# BMW Motorrad USA

## Service Information Bulletin

### **\*\*Notice of Recall 08V-239\*\***

**Subject:** Grubscrew not installed at the factory

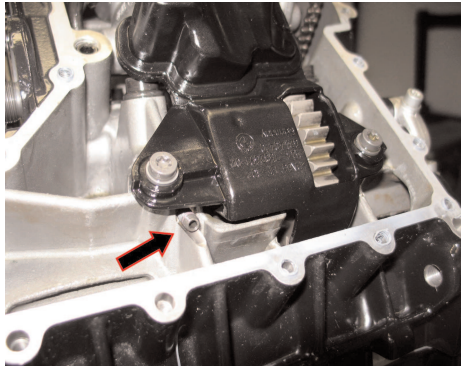
Clean the tapped hole (arrow) for the grubscrew.

Install the grubscrew (arrow) until seated and apply a final tightening torque of 8 Nm.
